Prairie Island Nuclear Generating Plant Units 1 and 2  
Dockets 50-282 and 50-306  
Renewed License Nos. DPR-42 and DPR-60

License Amendment Request to Adopt NFPA 805 Performance-Based Standard for Fire Protection for Light Water Reactors – Response to Request for Additional Information (CAC Nos. ME9734 and ME9735)

**Response to Request for Additional Information (RAI)**  
**Regarding the License Amendment Request to**  
**Adopt National Fire Protection Association (NFPA) Standard 805**  
**at Prairie Island Nuclear Generating Plant Units 1 and 2**

***PRA RAI 21.01***

Figure 1: Result of exposing each cable type to an exponentially increasing temperature or heat flux.

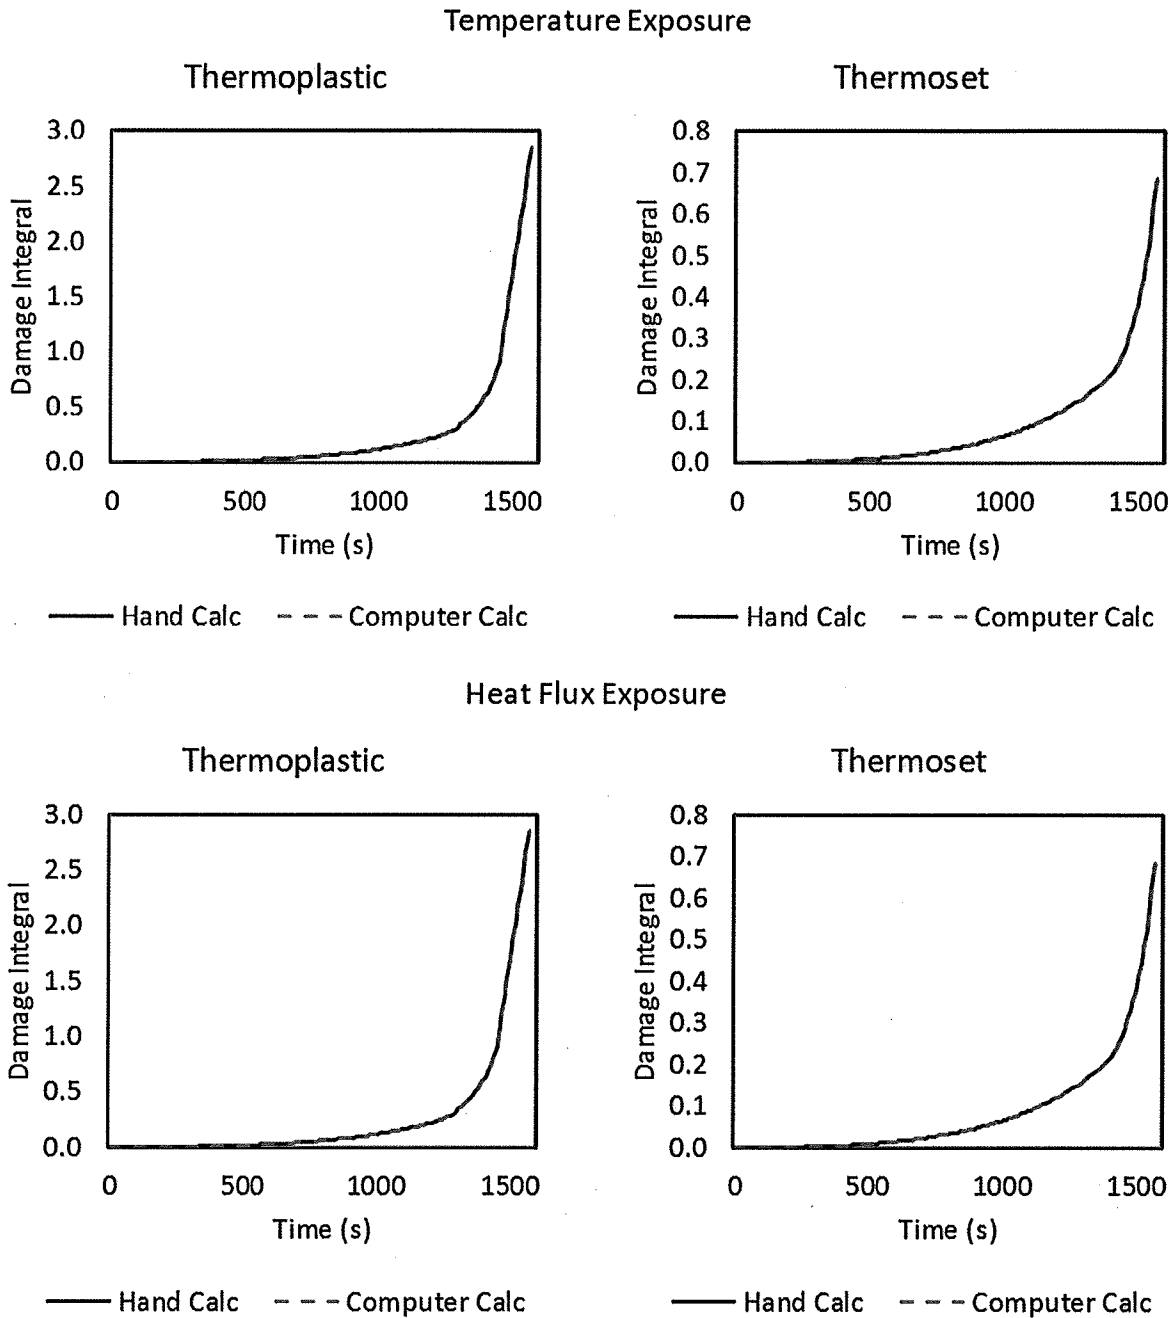
- 1. Provide the technical basis and the verification and validation to justify its use to determine ignition and damage delays.*
- 2. Discuss whether the method accounts for the effect of the preheating noted above.*

In addition, the computer code was verified against hand calculations. This was done by solving the damage accrual method by hand and comparing the results with the computer implementation. Each type of cable (i.e., Thermoset or Thermoplastic) was exposed to an exponentially increasing temperature or heat flux exposure with the accrual method computed both by hand and by using the computer model. The results are shown below in Figure 1 and indicate that the model was correctly implemented.
